PUBLIC INTEREST REVIEW FOR GROUNDWATER APPLICATIONS

TO: Water Rights Section Date 28 June 2010
 FROM: Groundwater/Hydrology Section Gerald H. Grondin
Reviewer's Name
 SUBJECT: Application G-17311 Supersedes review of N.A.
Date of Review(s)

A. GENERAL INFORMATION: Applicant's Name: Kenneth Hinckle County: Lake

Transient Stream Depletion (Jenkins, 1970; Hunt, 1999, 2003)
Proposed Well to Antelope Creek

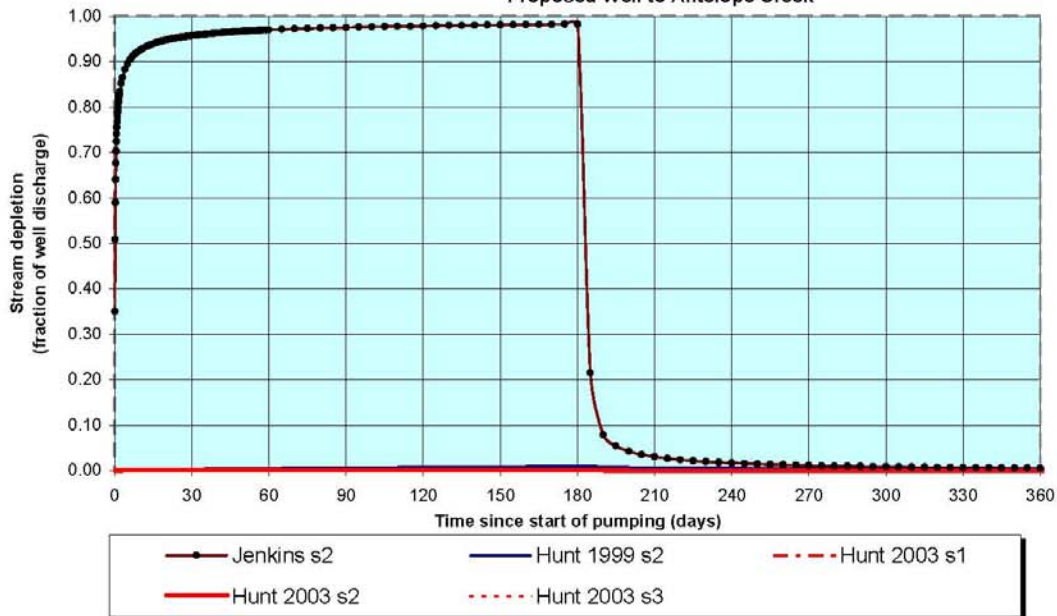
The proposed well is less than 0.25 mile from Antelope Creek and more than 1.0 mile from Cottonwood Creek.

A potential for substantial interference is assumed given the proposed pumping rate is greater than one-percent of the natural stream flow (80% exceedance).

Hunt (2003) was used to calculate the interference with Antelope Creek. The parameters used were a basalt horizontal hydraulic conductivity of 11.0 feet/day (transmissivity = 5500 ft²/day based on specific capacity data for LAKE 2306), an intermediate value of 0.001 for the storage coefficient, 500 feet of overlying basin-fill with a horizontal hydraulic conductivity of 10.6 feet/day (transmissivity = 5300 ft²/day based on specific capacity data for LAKE 2315 and 2763) and a vertical conductivity of 0.106 feet/day (aquifer horizontal conductivity/100), and an average stream width of 15 feet. These parameters are within the ranges found in Morgan (1988) and Gonthier (1985). A pro-rated pumping rate of 0.208 cfs (93.4 gpm) was used. It was derived from the total annual volume (76 ac-ft) divided by total seasonal time of use.

Transient Stream Depletion (Jenkins, 1970; Hunt, 1999, 2003)
Proposed Well to Cottonwood Creek

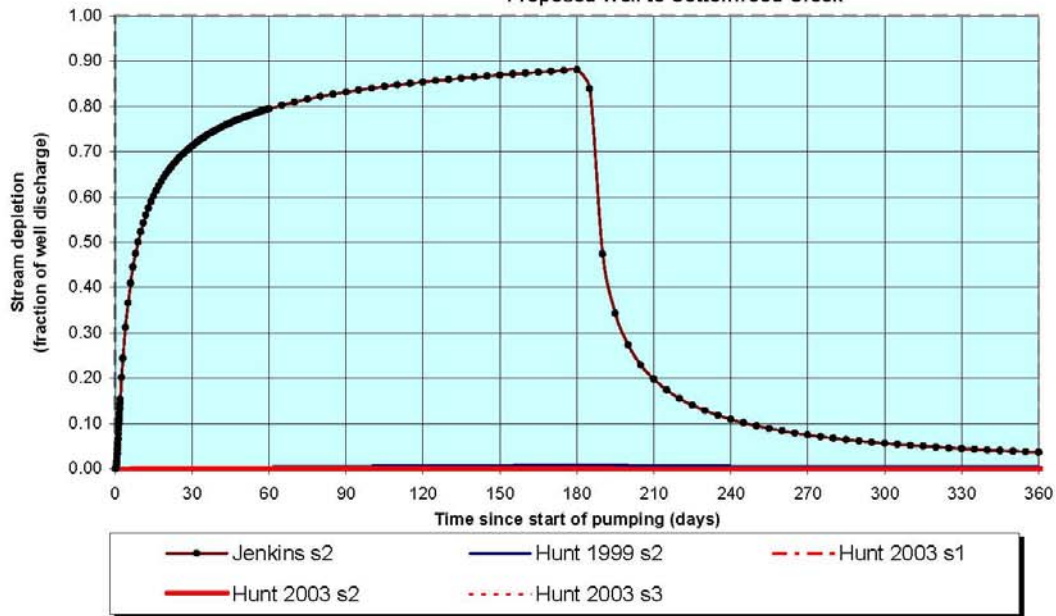
The proposed well is more than 1.0 mile from Cottonwood Creek.

Hunt (2003) was used to calculate the interference with Cottonwood Creek. The parameters used were a basal horizontal hydraulic conductivity of 11.0 feet/day (transmissivity = 5500 ft²/day based on specific capacity data for LAKE 2306), an intermediate value of 0.001 for the storage coefficient, 500 feet of overlying basin-fill with a horizontal hydraulic conductivity of 10.6 feet/day (transmissivity = 5300 ft²/day based on specific capacity data for LAKE 2315 and 2763) and a vertical conductivity of 0.106 feet/day (aquifer horizontal conductivity/100), and an average stream width of 15 feet. These parameters are within the ranges found in Morgan (1988) and Gonthier (1985). A pro-rated pumping rate of 0.208 cfs (93.4 gpm) was used. It was derived from the total annual volume (76 ac-ft) divided by total seasonal time of use.
